BMP NUMBER: PC081

Marsh Hawk Course Holes 1-18

**ENVIRONMENTAL DIVISION REVIEW COMMENTS
FORD'S COLONY LOT 103 SECTION 10 (109 HOLLINWELL)
DIVISION PLAN NO. E&S - 08 - 08**

**AS-BUILT SURVEY A PORTION OF HOLLINWELL AND LOT 103, SECTION X
FORD'S COLONY @ WILLIAMSBURG**

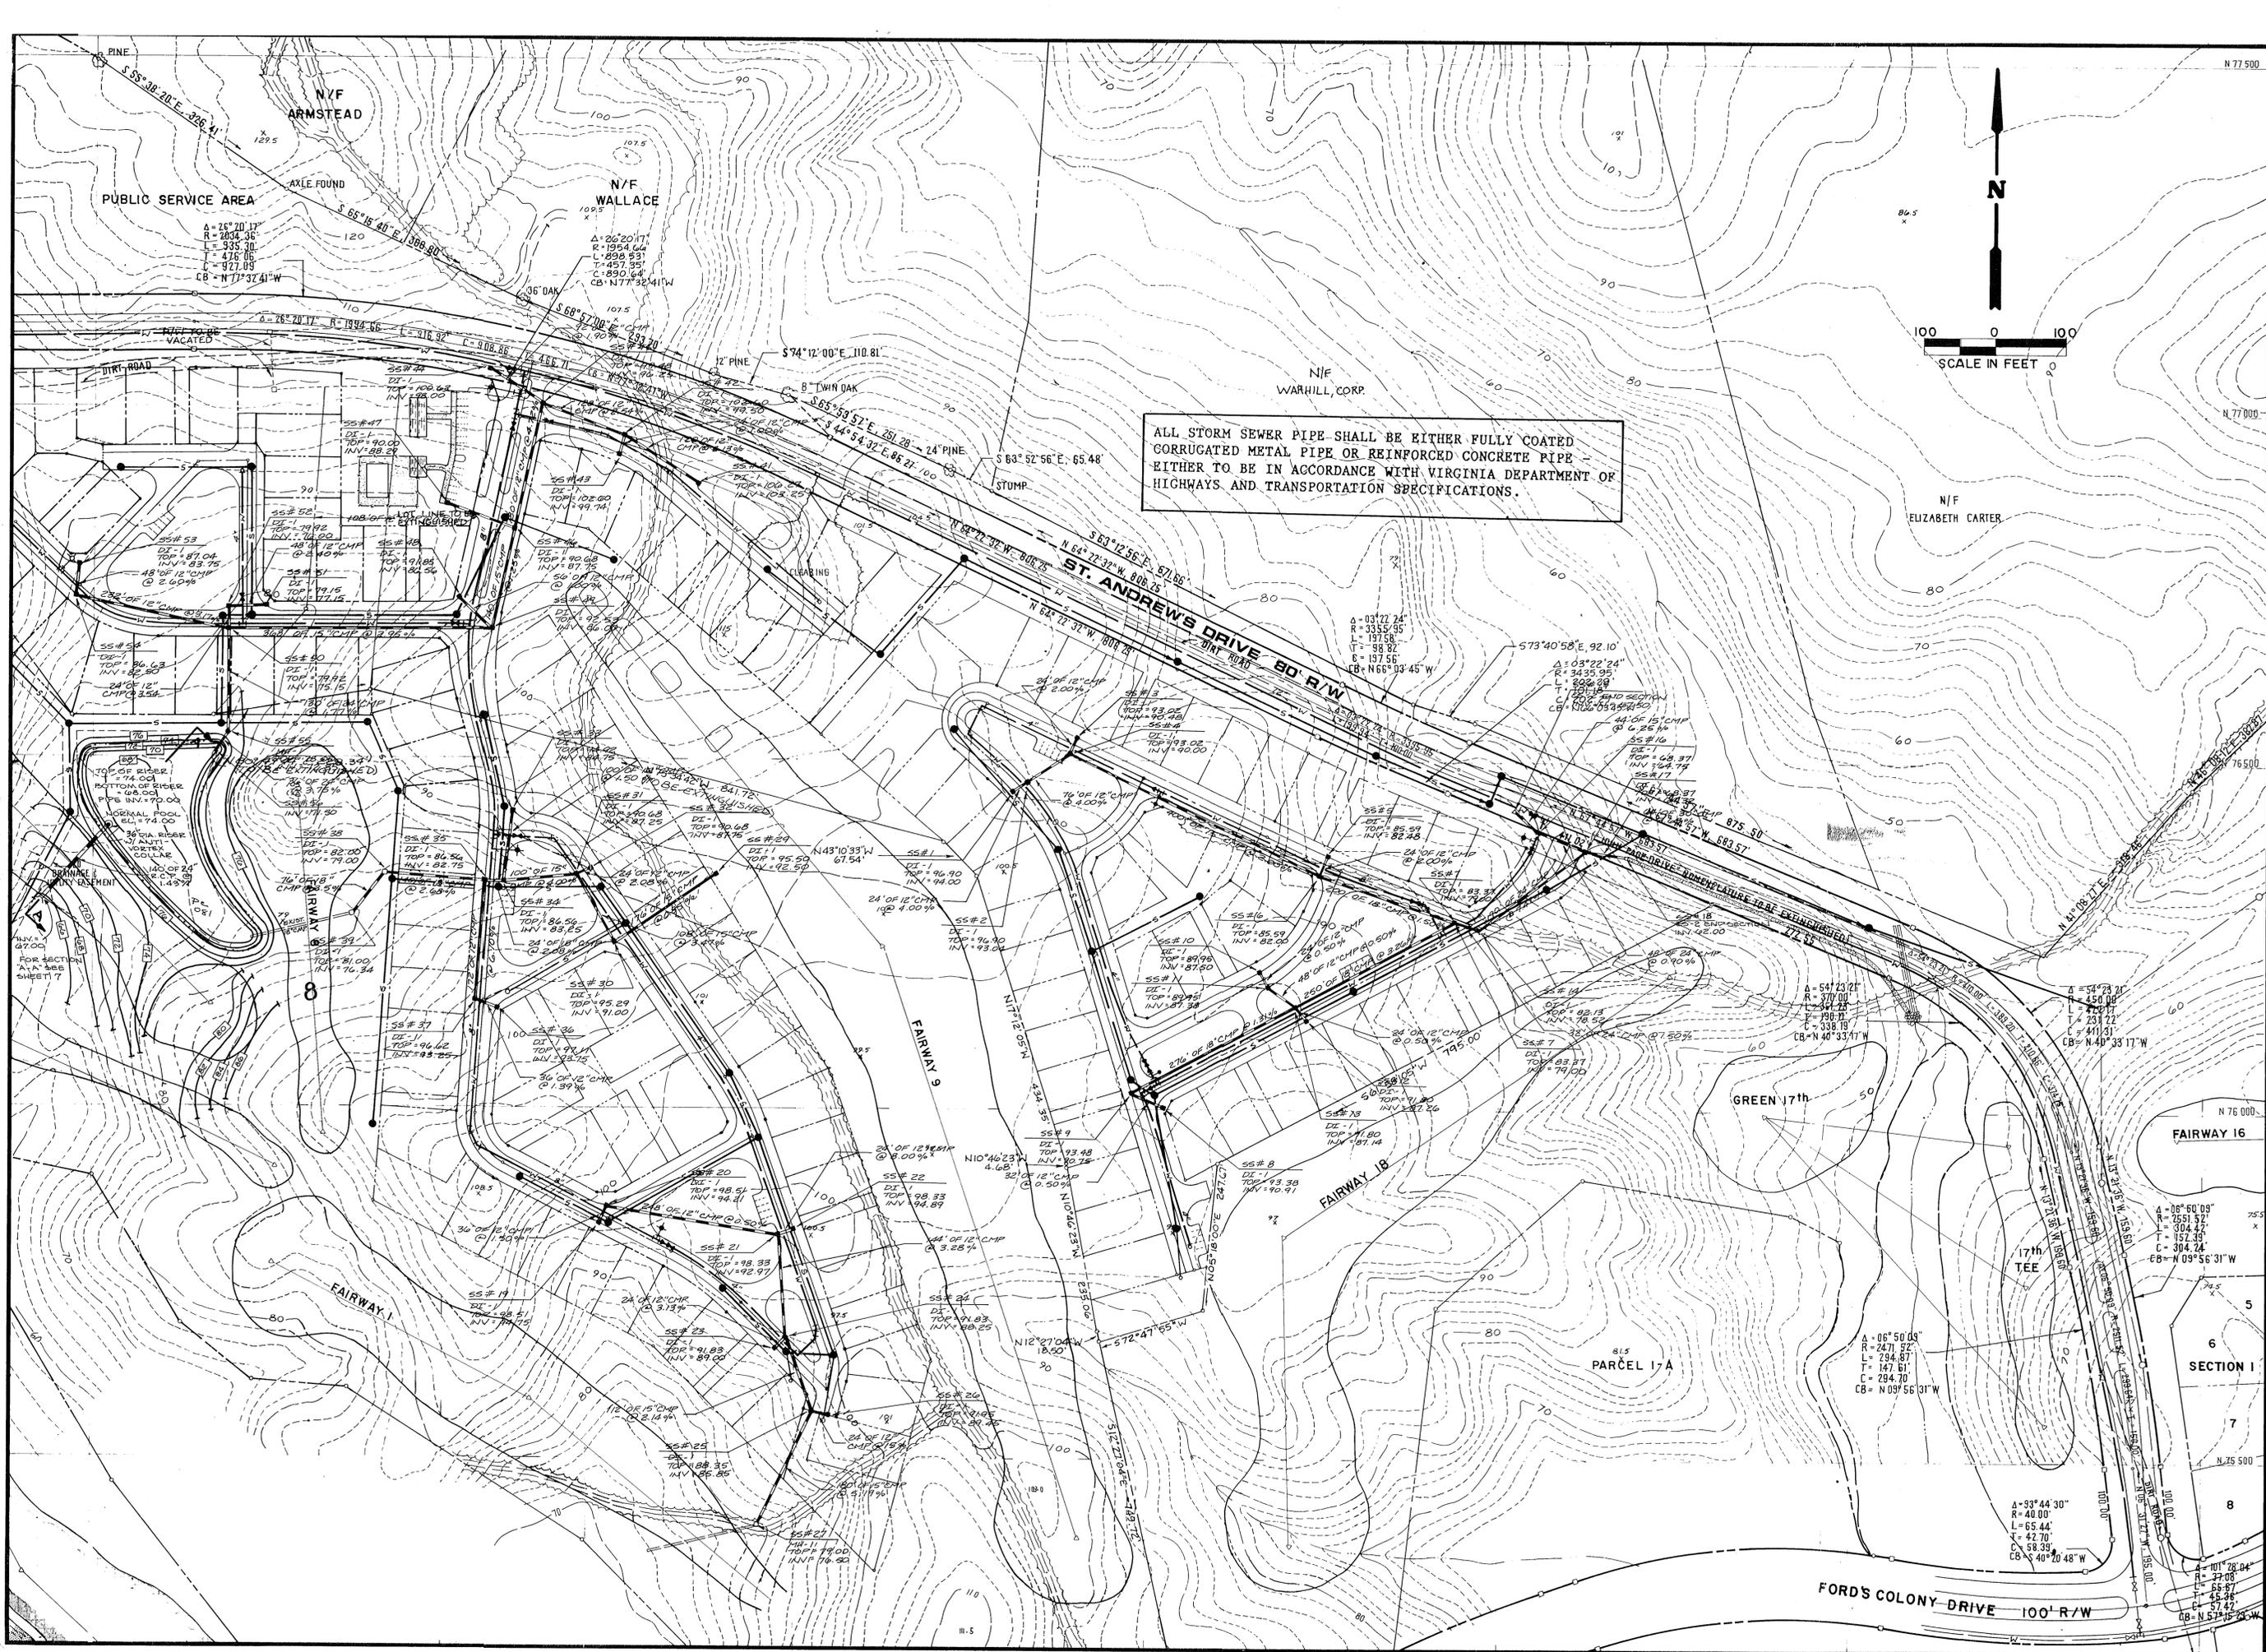
Upon reviewing the as-built information collected in the field, a few items are to be noted. The diameter of the piping system has been built in accordance with the construction plans. The elevations of the structure tops and inverts have deviated from the design elevations. Once this was recognized, hydraulic calculations were performed on the outfall of the system using the as-built elevations and original design flowrates. The hydraulic model indicates that the ten year design storm does not surcharge the system into the street, although there is minimal freeboard. It should be anticipated that larger storm events will cause the inlet at the street in front of Lot 103 to flood. It is important to note that this is under ideal conditions, which assumes there is no clogging of the inlets or pipe system. Any clogging would increase the flood potential. It was also noted that the inlet at the sump of Hollinwell adjacent to Lot 103 is in poor condition, specifically the pipe inlets into the structure.

The elevations of the existing improvements to Lot 103 are also of concern. The finish floor of the garage is approximately 2 feet below the elevation of the street at the driveway tie-in location. The majority of the driveway is graded towards to garage and there is minimal slope on the driveway to convey the drainage away from the building. Upon reviewing the approved development plan for Lot 103, it was noted that the garage was built approximately 1.5 feet lower than the design elevation. Three drainage inlets have been installed at the edge of the driveway to help convey the water off of the property. These three inlets drain to the main drainage system, described above, which is located to the west of Lot 103. Two of these three inlets were clogged during the field inspection which would render them useless during a storm event.

Based on the as-built survey, the grading of the front yard of Lot 103 is further increasing the flood potential into the garage. The emergency water route is blocked by the existing mulch bed at the northwestern most corner of the house. Additionally, the grade of the front yard falls towards the inlets at the driveway. During a minimal storm event, it is anticipated that water would flow into the garage. This is a significant problem and the front yard should be regraded to provide positive drainage away from the driveway to the existing ditch in the greenway on the western side of the house. Based on the existing grading, if the inlet along Hollinwell becomes clogged during a storm event, the water would breach the curb and further increase the amount of runoff to the drains at the driveway.

It is our recommendation that the inlets at the driveway be removed in their entirety, from the driveway to the main pipe system, to include repairing the connection point. The front yard should be regraded to provide positive drainage from the driveway to the greenway on the west side of the homesite. This can be accomplished by grading a grass swale approximately 70 feet long from the driveway to the existing ditch. Reworking of the landscaping in the front yard is also necessary to prevent impeding the flow of water to the greenway. Routine maintenance of the roadway drainage system should also be performed to prevent clogging of the roadside drainage inlets.
